Access Compliance Report

Public Rights-of-Way

(Curb Ramps)

Intersection ID: 43354	Main Street: LAKERIDGE_COMMONS_DR	Cross Street: PROSPERITY_COMMONS_DR	Location:	N
ADA ID: 3A9C88149883	Ramp Type: PerpDiag	Initial Pass/Fail: Fail	Overall Compliance: No	Severity Score: 22.5
Codes/Mitigation Info/Possible Solution		Field Measurements/Component Compliance

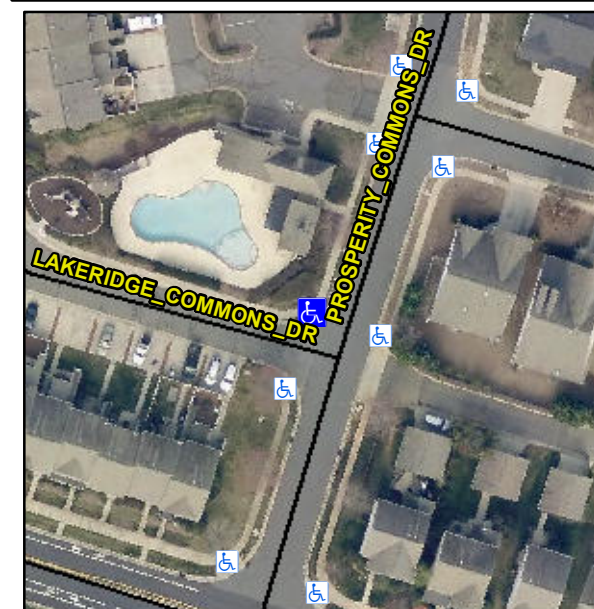
Not Found, R304.5.1, R304.2.2, R304.5.3

Compliance	Description	Data	Compliance	Description	Data
N/A	Ramp Length (in)	47.0	No	Ramp Slope (%)	11.2
No	Ramp Width (in)	37.5	No	Ramp XSlope (%)	3.2
N/A	Flare Type LT	N/A	N/A	Flare Type RT	N/A
N/A	Flare Slope LT (%)	N/A	N/A	Flare Slope RT (%)	N/A
N/A	Flare Traversable LT?	N/A	N/A	Flare Traversable RT?	N/A
N/A	Landing Length (in)	N/A	N/A	DWS Provided?	N/A
N/A	Landing Width (in)	N/A	N/A	DWS Contrast?	N/A
N/A	Landing Slope (%)	N/A	N/A	DWS Length (in)	N/A
N/A	Landing X Slope (%)	N/A	N/A	DWS Full Width?	N/A
N/A	Landing Curb? (Y/N)	N/A	N/A	DWS Offset (in)	N/A
N/A	Shared Landing?	N/A			
N/A	Gutter Ponding?	N/A	N/A	Gutter Slope (%)	N/A
N/A	Gutter Lip Ht (in)	N/A	N/A	Gutter X Slope (%)	N/A
N/A	Painted X Walk1?	No	N/A	Painted X Walk2?	No
	X Walk 1 Direction	To SW		X Walk 2 Direction	To SE
N/A	X Walk 1 Width (in)	N/A	N/A	X Walk 2 Width (in)	N/A
	X Walk 1 Slope (%)	2.3		X Walk 2 Slope (%)	2.9
	X Walk 1 X Slope (%)	0.8		X Walk 2 X Slope (%)	2.5

Remove & Replace Curb Ramp With Two New Directional Ramps or Equivalent.
